Technical Bulletin No: 101 – Output Board Static Protection

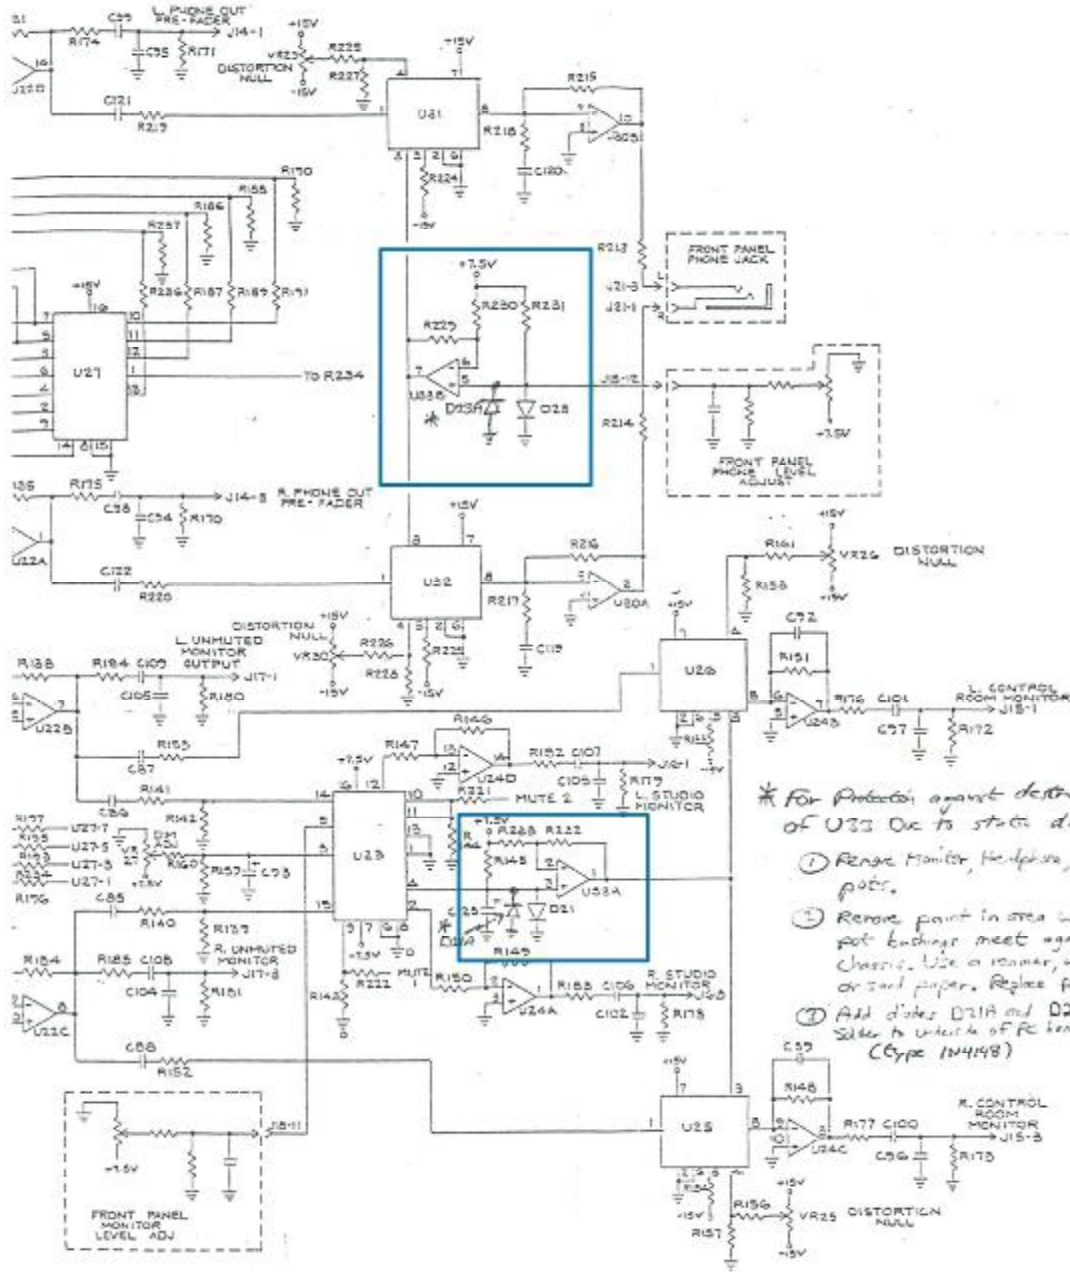
* For Protection against destruction of U33 due to static discharge:

- ① Remove Monitor, Headphone, and cue pots.
- ② Remove paint in area where pot lugs meet against chassis. Use a scanner, wire brush or sand paper. Replace pots.
- ③ Add diodes D21A and D23A. Solder to under side of PC board. (Type 1N4148)
